Franklin County Planning Commission

Wednesday, December 13, 2017

MINUTES OF THE FRANKLIN COUNTY PLANNING COMMISSION

Planning Commission
December 13, 2017

PRELIMINARY PLAN FOR MORRISON FARMS EAST

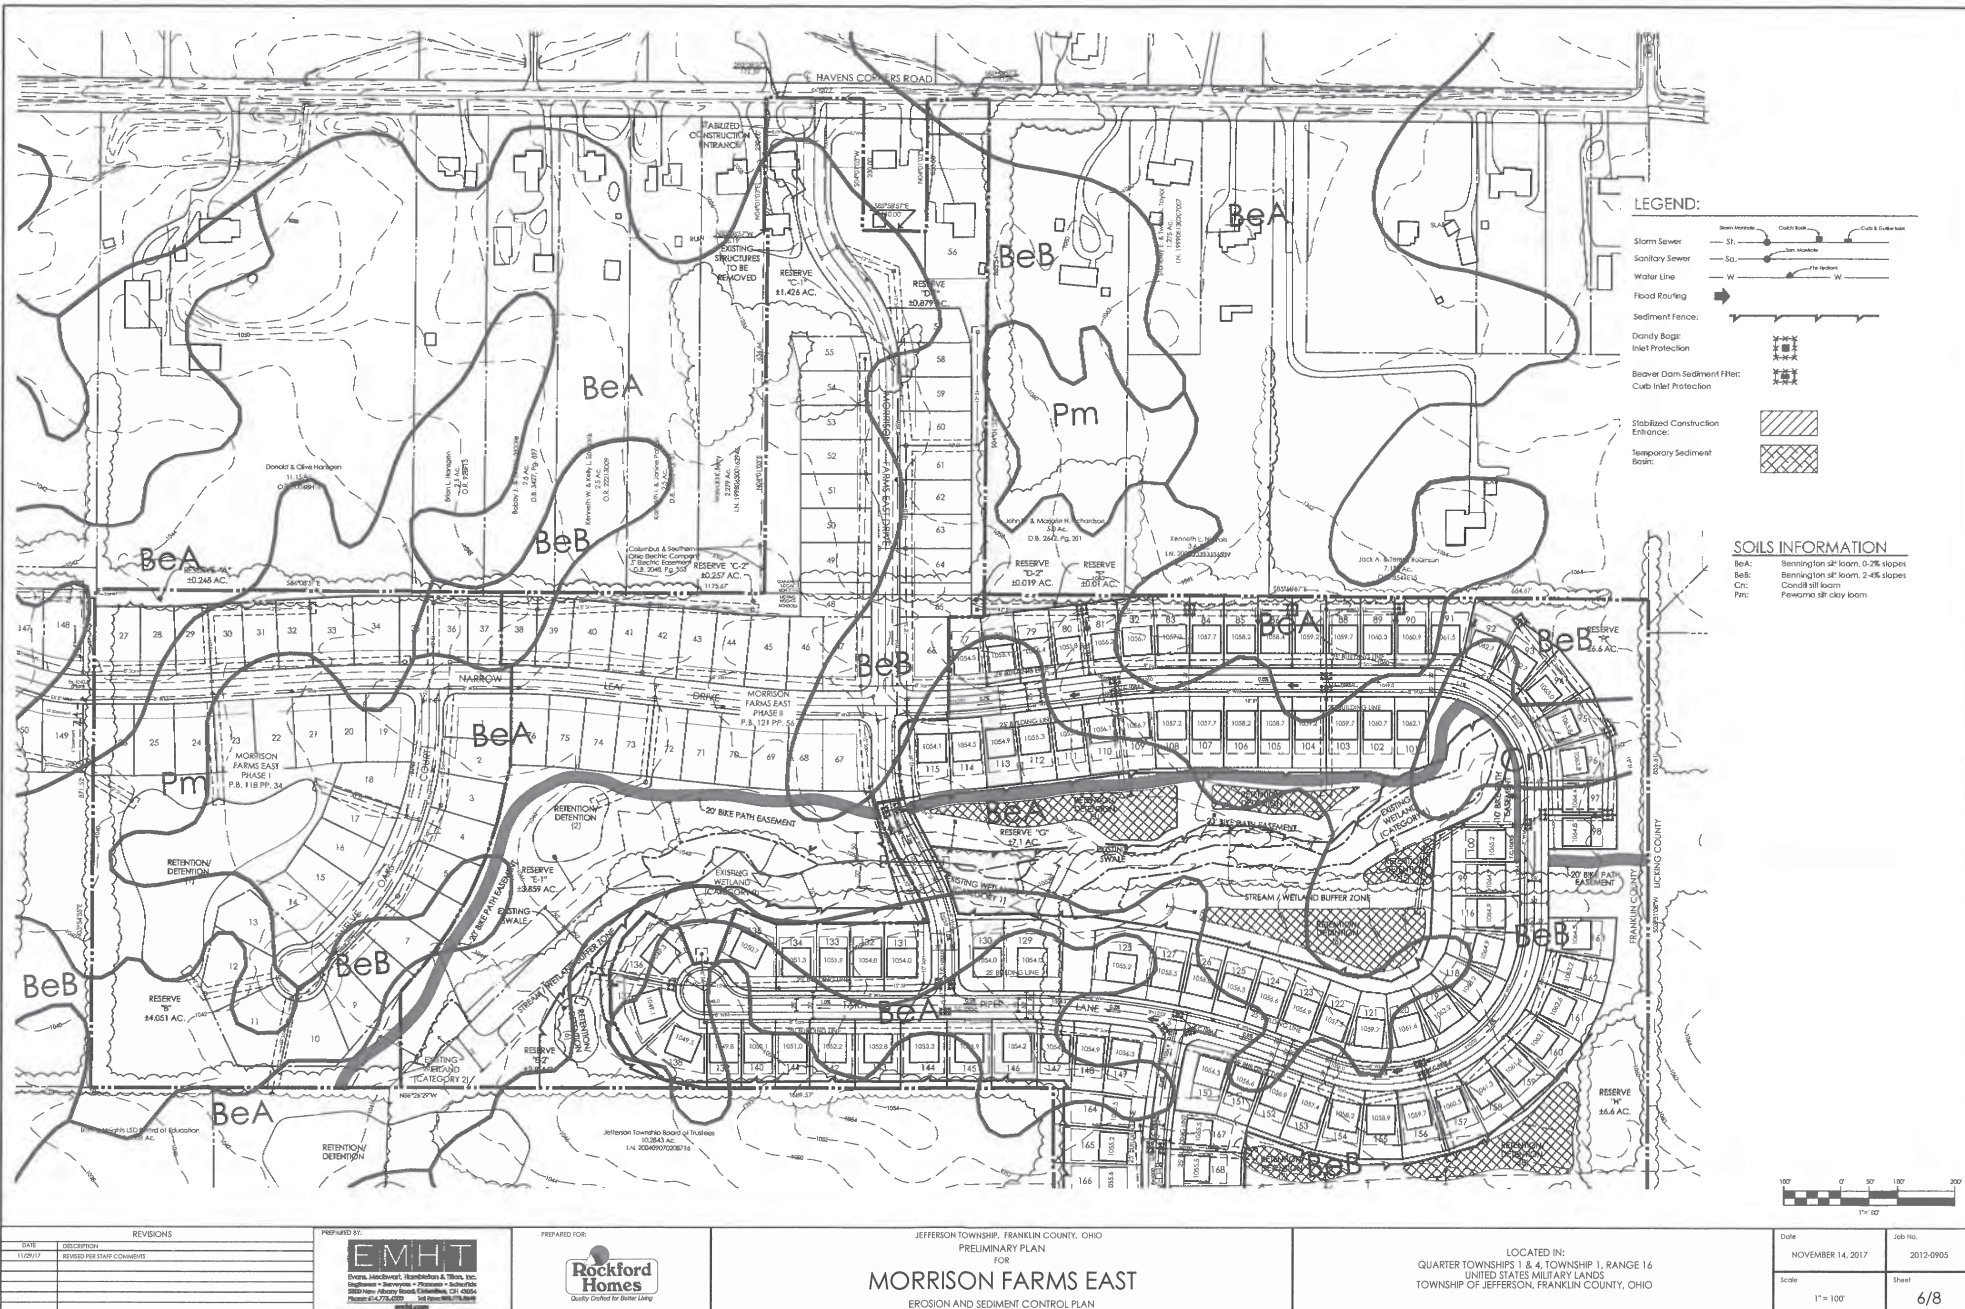
The applicant is now seeking to revise the approved Preliminary Plan for Phases 3-6 to adjust the Phase boundary between Phases 3 and 4. The revised Preliminary Plan has also included updated lot numbering and reserve statistics based on the approved Final Plats for Phases 1 and 2.

The proposed Preliminary Plan revision does not change the site layout, number of lots or amount of open space within the development. The change in the phase boundary will allow a stream crossing originally planned for Phase 3 to be installed in Phase 4. This stream crossing is not required to serve or provide access to any lots in Phase 3.

Technical Review Agencies expressed no concerns with the proposed Preliminary Plan revision.

Staff recommends **conditional approval** of the revised Preliminary Plan for Morrison Farms East Phases 3-6.

1. The stream buffer zone label along Rameys Run Creek must be revised on the final plat to be a stream buffer zone/drainage easement.

Figure 9: Existing Condition B: Maple to Brown Street on West Broad Street in the Western Gateway Sub-District

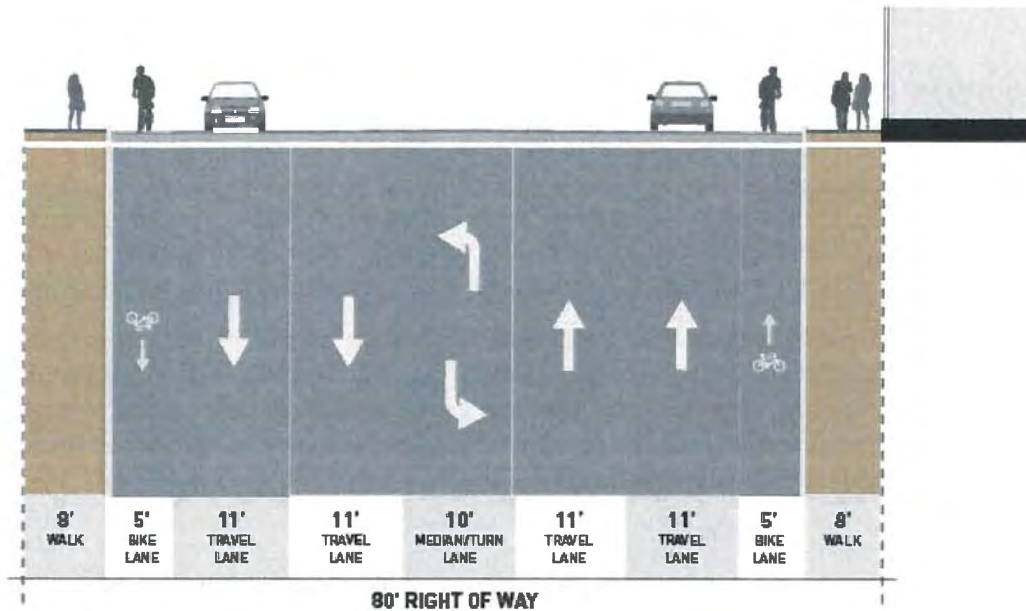
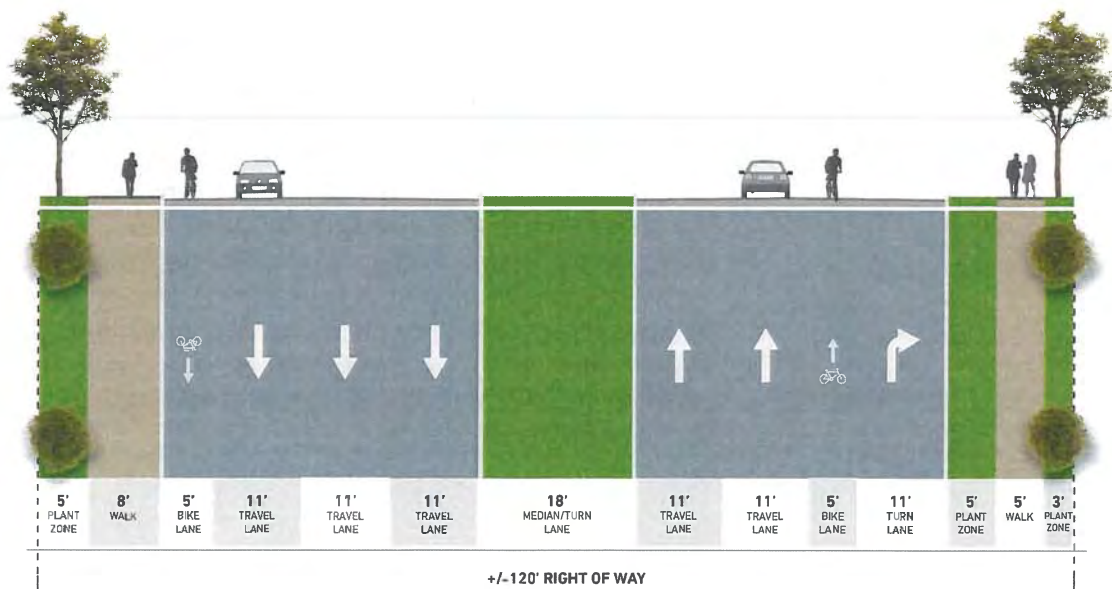
Illustrations are provided to clarify the intended right-of-way design, building height, setback lines, architectural features, parking location, and street tree location. These illustrations are for clarification and are not regulatory. Figures 9 and 10 appear to be numbered incorrectly.
